Proposal for amendments to UN Regulation No. 67 (LPG vehicles)

The text reproduced below was prepared by the expert from Italy to amend UN Regulation No. 67 to introduce the new filling unit profile “J15” as specified in ISO 19825 and to align with the same standard the naming of Euro filling unit.

Figure 6
Connecting area of the J15 filling unit

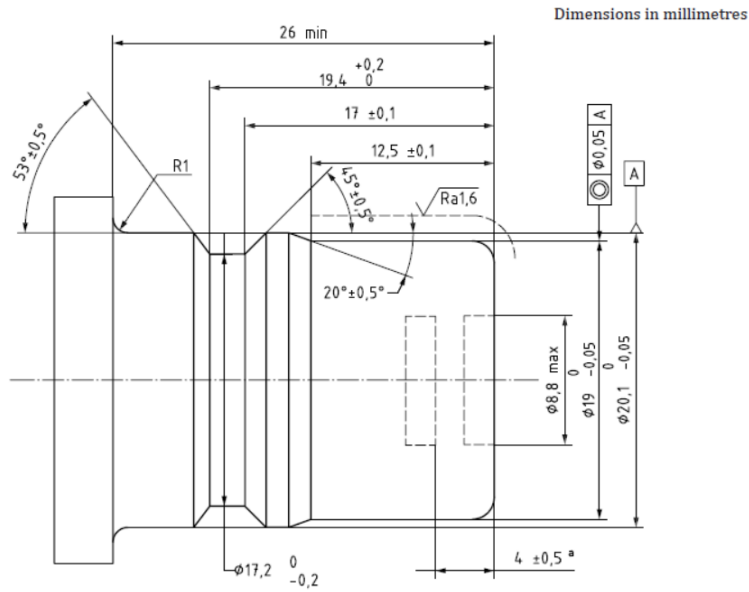
Insert a new Figure 6:
